RIN 0648-XA811

**Takes of Marine Mammals Incidental to Specified Activities; Taking Marine Mammals Incidental to an Exploration Drilling Program in the Chukchi Sea, Alaska**

**ACTION:** Notice; issuance of an incidental harassment authorization.

Figure 1. Source levels in 1/3-octave bands for the drillship Discoverer and ice management surrogate vessel (the ice handler Maersk Rover).

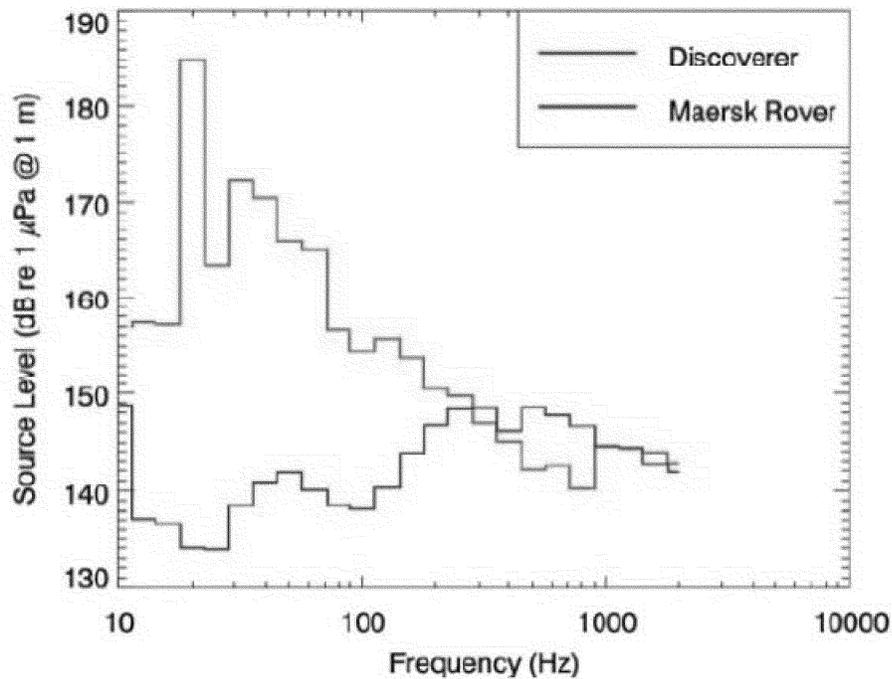
*Comment 26:* The MMC states that it is not clear which specific source level was used to model the size of the corrected 120-dB re 1  $\mu$ Pa harassment zone for the *Discoverer*, as the reported source levels for the *Discoverer* ranged from 177–185 re 1  $\mu$ Pa at 1 m. It also is not clear how the source level measurements taken in the South China Sea were incorporated in the model to estimate the 120-dB re 1  $\mu$ Pa harassment zone in the Chukchi Sea.

*Response:* The modeling analysis considered 1/3-octave band levels to account for frequency-dependent propagation effects that cannot

adequately be characterized with broadband analysis. The 1/3-octave band source levels were obtained from dedicated measurements of the *Frontier Discover* (now *Noble Discoverer*) during drilling activities in the South China Sea. A plot showing these levels is provided in the response to *Comment 27*, and the corresponding broadband levels could be computed by summing those if required. The modeling approach applied by JASCO Applied Science was the MONM parabolic equation acoustic propagation model in each 1/3-octave band from 10 Hz to 2 kHz. The resulting received band levels were summed to compute the broadband received levels at many depths, distances and directions from the planned drillship location. Representative sound level threshold radii were determined by calculating the 95th percentile distance, over all azimuths, at which the maximum threshold over all depths was received. This approach considers that animals may sample multiple depths as they pass by the drilling operation.

Figure 2. Temperature, salinity, and sound speed profiles at the Burger prospect obtained from the GDEM database for October.

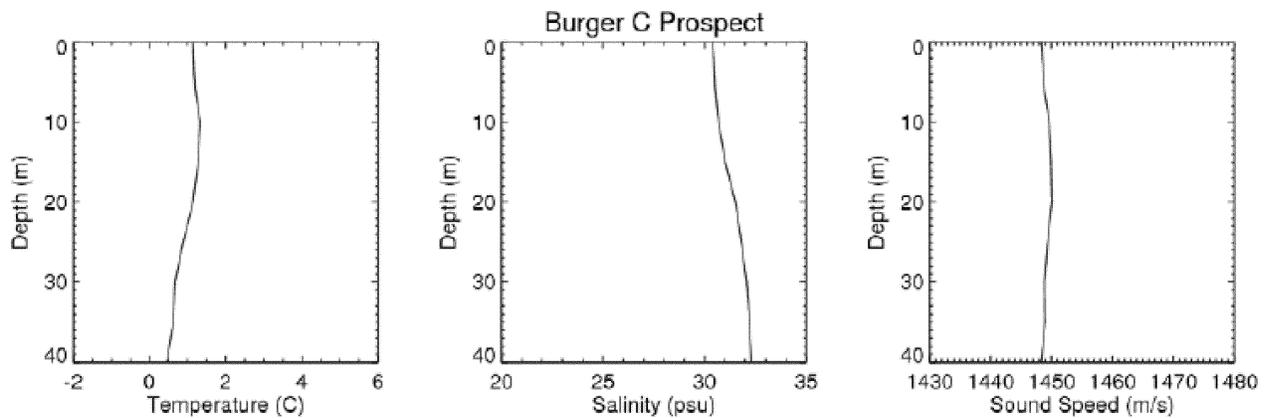
*Comment 29:* Dr. Bain states that the correction factor of 1.5 applied to the distance to the 120 dB contour is inadequate to conservatively account for the variability.

*Response:* The concern raised here is that the sound speed profile used for acoustic modeling of drill rig noise may not account for changes to the salinity and temperature profile that could influence and create variability in sound propagation, and the resulting variability might lead to conditions in which model estimates would not be conservative. The location-specific sound speed profiles considered for this modeling study were obtained from the GDEM database for conditions in July and October. A modeling study (Johnston *et al.*, 2009) investigated the difference in sound propagation for both months and showed longer-range sound propagation using the October profile. To be precautionary and to avoid underestimating the propagation, the modeling at the Burger prospect that was used for marine mammal effects assessment was conducted using the October profile (see Figure 2). Therefore, a correction factor of 1.5 is appropriate in this circumstance.

Figure 3. Band levels for the Kulluk during drilling.

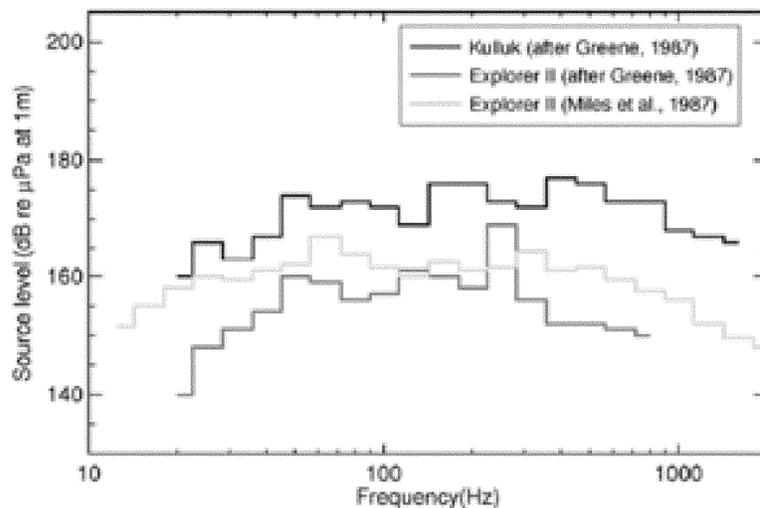
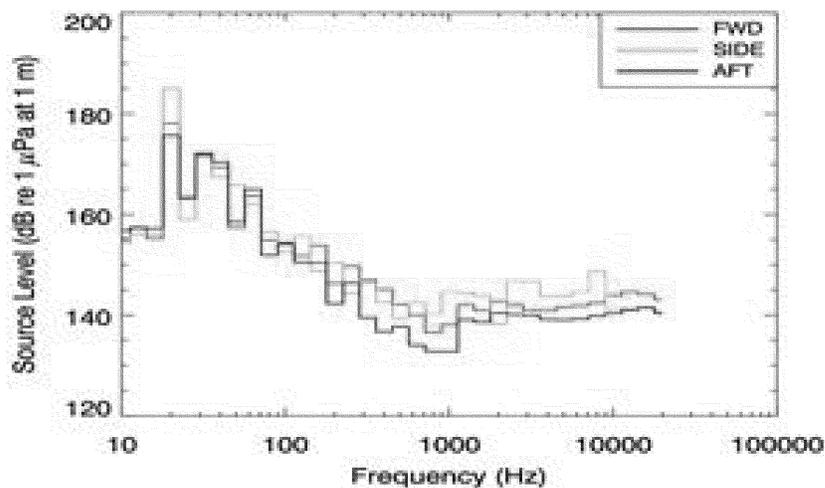
*Comment 37:* The NSB and AWL note that the modeled 120-dB isopleths for the *Discoverer* are different in the Beaufort and Chukchi Seas (with the isopleth being slightly smaller in the Chukchi Sea). Additionally, they question if the 120-dB isopleth for the *Discoverer* is correct given its nearly identical source level to the *Kulluk* drill rig (proposed for use in the Beaufort Sea), for which sound propagates out to the 120-dB isopleth at a much farther distance. If the modeled propagation is incorrect for the *Discoverer*, then this would bias the take estimates low.

*Response:* The primary reason for the difference in the distance of the 120-dB isopleths for the *Discoverer* in the Beaufort Sea vs. the Chukchi Sea is due to differences in the geoacoustic parameters for the two seas that were input to the model. Water depth, seabed density, and seabed sound speed are generally the most important parameters that influence sound propagation.

Differences in sound propagation from the two rigs are real and are caused by differences in the design of the two vessels. While the broadband source levels for the *Discoverer* and *Kulluk* may be similar, their spectral properties differ considerably. Acoustic modeling considers the source levels in 1/3-octave frequency bands. Figures 3 and 4 show the band levels for both drillships during drilling. Of key importance are the significantly lower levels of the *Discoverer* in the 50 to 500 Hz bands that propagate well in the relatively shallow waters of these drilling operations. While the *Discoverer* apparently has higher band levels below 50 Hz, this energy is more rapidly attenuated than higher frequency sound energy. This characteristic of sound propagation in shallow waters leads to predominantly mid-frequency sounds (50–500 Hz) dominating the acoustic field at distance from the drillships. A further consideration is that the *Kulluk* source levels are known to include contributions from support vessels, and much of the mid-high frequency band
